AN ORDINANCE ACCEPTING THE BID OF R.W. CLARK COMPANY, INC. OF CLEVELAND, OHIO, FOR THE GASHOLDER BUILDING RENOVATION, PHASE I EXTERIOR IMPROVEMENTS, IN THE CITY OF OBERLIN AND DECLARING AN EMERGENCY

ADDENDUM NO. 1

**GASHOLDER BUILDING RENOVATION
OBERLIN, OHIO 44074**

**PHASE 1 – EXTERIOR RESTORATION
PID 75844
FAN OH03003
LOR – Gasholder House**

DETAIL AT EAVE

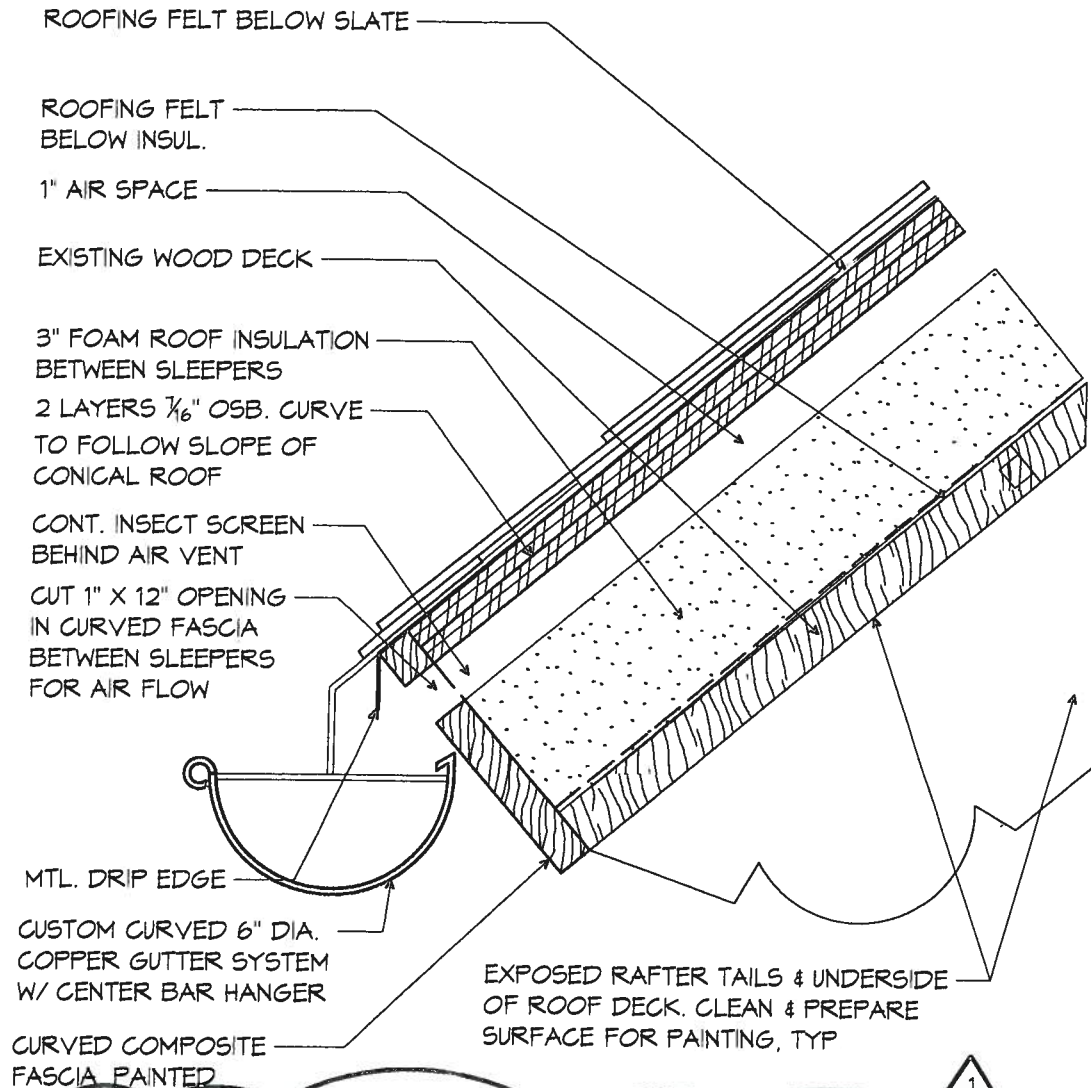
- A. Sheet A8.1: Detail 11 – See attached revised sketch ASK-01.
B. Sheet A8.1: Detail 2 – See attached revised sketch ASK-02.
C. Sheet A8.1: Detail 2 – See attached revised sketch ASK-03.
D. Sheet A8.1: Detail 4 – See attached revised sketch ASK-04.
E. Sheet A4.2: Detail 10 – See attached sketch ASK-05 for new copper metal cap detail.
F. Sheet A4.2: Detail 11 – See attached sketch ASK-06 for new copper metal cap detail.
G. Sheet A4.2: Detail 12 – See attached sketch ASK-07 for new copper metal cap detail.
H. Sheet A1.1:
1. Under Floor Plan Coded Notes, revise note 26 to read, “Line of wood sleepers below. Typical at entire roof. Below the compression ring, the location of sleepers is to exactly follow location of existing rafters below. Above the compression ring, provide sleepers at all existing main rafters and adequate sleepers in between parallel to the rafters. Locate all sleepers

A-SK05

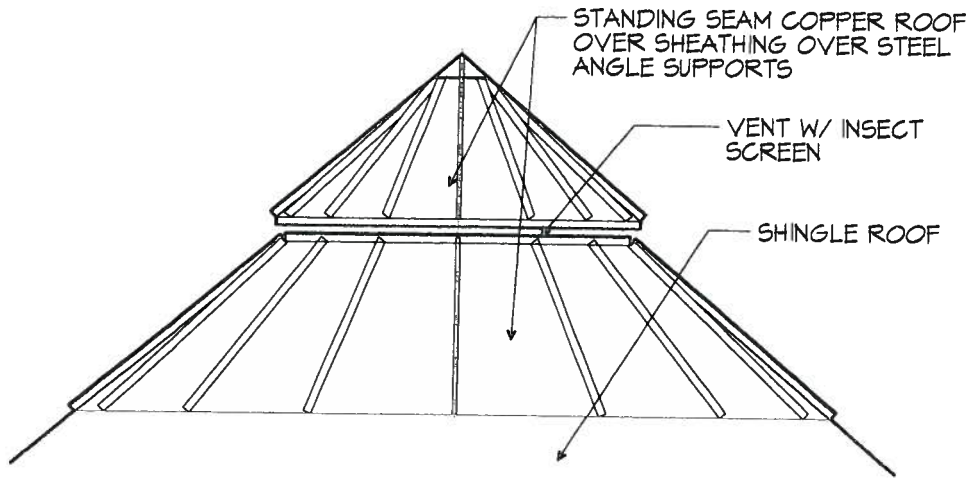
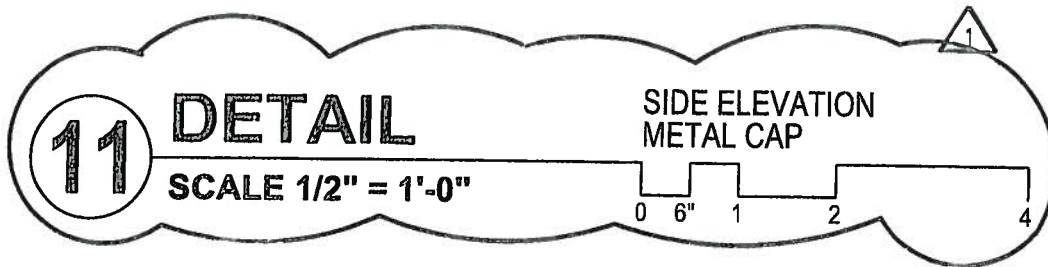
2. Under Floor Plan Coded notes, revise note 9 to read.” Provide new copper metal cap per details.” See sketches ASK-05 – ASK-07.
-
- I. Sheet A3.2: Under Elevation Coded notes, revise note 6 to read, “Provide new copper metal cap per details.” See sketches ASK-05 – ASK-07.

NOTE:
CONTRACTOR IS RESPONSIBLE FOR PROVIDING
STEEL ANGLE SUPPORTS BRACED APPROPRIATELY
FOR STRUCTURAL INTEGRITY OF METAL CAP.
PROVIDE ADEQUATE SUPPORT/ATTACHMENT OF
COPPER TO SUBSTRATE. PROVIDE SHOP DRAWINGS FOR
ARCHITECTS REVIEW AND APPROVAL PRIOR TO
FABRICATION.
